National Landing Water Park

ARLINGTON, VA

3CA COMMUNITY PRESENTATION

TREE PRESERVATION REVISION DIAGRAM

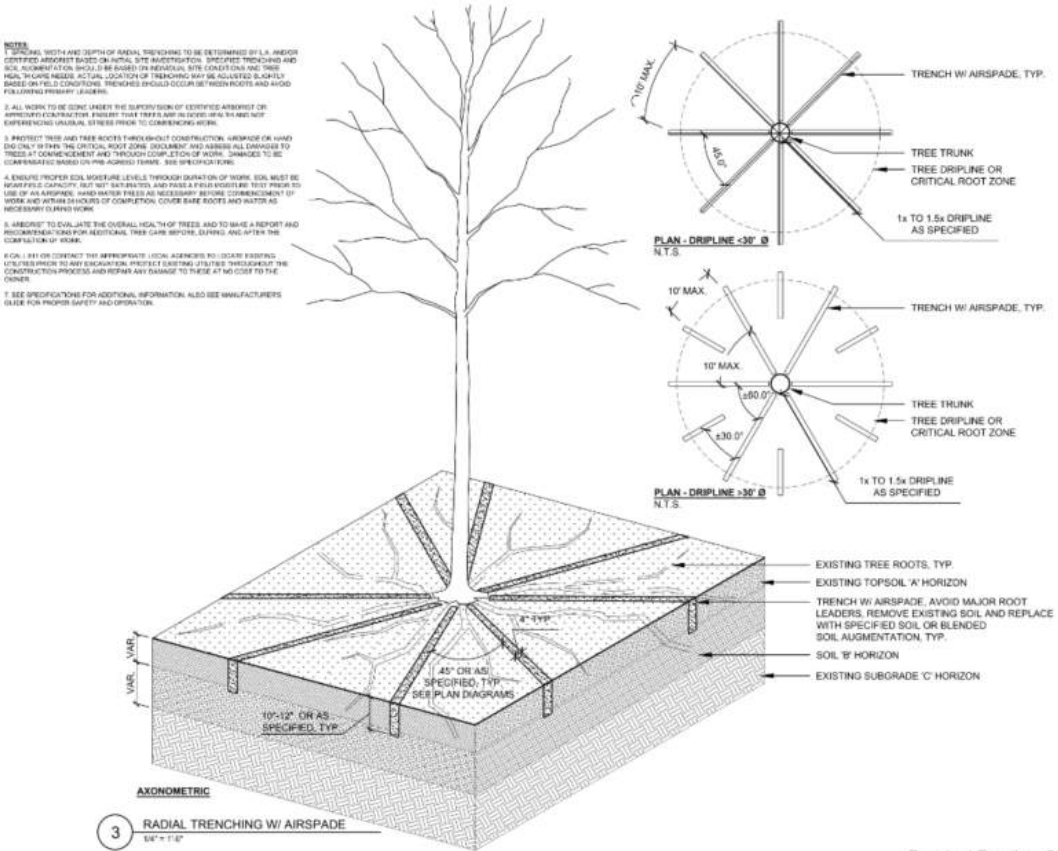
- NOTES:**
- 1. This proposal will provide additional trees per the county requirements
 - 2. The latest design iteration provides 150 tree replacements. The current proposal requires ±125 replacements. Pending the final replacement calculations the final tree counts will balance with other site requirements.
 - 3. Tree removal revisions have been shared with Arlington County and will be revised in all subsequent submissions.

Tree ID	Approved MSPA	Current Proposal	Cailper Size (DBH)	Condition Rating	Replacement Value	Notes
T16	Preserve	Remove	5	1.9	1	Removal due to streetscape improvements
T35	Preserve	Remove	12.5	4.8	1	Removal due to fountain infrastructure alignments
T37	Preserve	Remove	12	4.6	1	Removal due to fountain infrastructure alignments
T75	Preserve	Remove	11	3.9	1	Removal due to fountain infrastructure alignments and adjacent site conditions
T76	Preserve	Remove	11	3.9	1	Removal due to fountain infrastructure alignments and adjacent site conditions
T122	Preserve	Remove	7	3.7	1	Removal due to grading
T123	Preserve	Potential Preserve	16	7.8	2	Preservation pending hydrant relocation per Fire Marshall
T125	Preserve	Remove	16.5	9.2	2	Utility conflicts, park access and grading issues prevent preservation
T128	Preserve	Potential Preserve	18	9.5	2	Preservation pending hydrant relocation per Fire Marshall
T152	Remove	Preserve	3	1.8	0	Revised utility alignment and landscape bed layout

Since the approval of the MSPA (early 2021) additional site information has been discovered and further design progress has resulted in additional constraints related to tree preservation.

- 1. Subsurface soil investigation (late March 2021) revealed that the soil conditions on the site are extremely poor.** This has revised the overall condition rating of the trees and made us rethink the tree preservation details. When the park was constructed the guidelines were not as prescriptive for soil volumes for trees. Our team is balancing the preservation of the existing trees with providing new soil for the existing trees without disturbing the root structure. The technique is refereed to as radial trenching. The typical detail has been provided to the right.

- 2. Dry utility alignments were only conceptual and some were unknown at the time of the MSPA Approval.** This additional information has been advanced and coordinated and been revised numerous times to allow for the preservation of as many trees on the northwest corner of the site as possible. This corner of the site is very busy with utility connections, grading and sight lines and these have all been carefully considered in the design.

- 3. ADA requirements and site access led to the removal of T125.** The new ADA ramp from Crystal Drive and the adjacent site improvements to open the north end of the park were in conflict with preserving T125.

- 4. At the time of the approved MSPA the fountain infrastructure was still evolving.** Our team was hopeful to reuse as much of the existing infrastructure as possible. It was determined that the better option was to provide new connections for portions of these features which minimizes the impact to the water wall feature. This led to the removal of T35, T37, T75 and T76.

- 5. T16 and T122 were not great candidates for preservation due to their size and condition rating.**
- 6. As noted in the following pages our team is hopeful to preserve T123 and T128 but in order to do so will require the relocation of an existing fire hydrant. Our team has made this request and is awaiting a response from the Fire Chief.**

TREES REMOVED: 82
REPLACEMENT VALUE: 124
REPLACEMENTS PROVIDED: 127

TREES REMOVED: 89
REPLACEMENT VALUE: 125
REPLACEMENTS PROVIDED: 138

* These calculations are currently being evaluated and managed to meet multiple project goals including but not limited to the pending preservation of trees T123 & T128, soil volume calculations and final utility routing and coordination. These issues have been discussed with Arlington County and will be finalized prior to the issuance of any submissions.
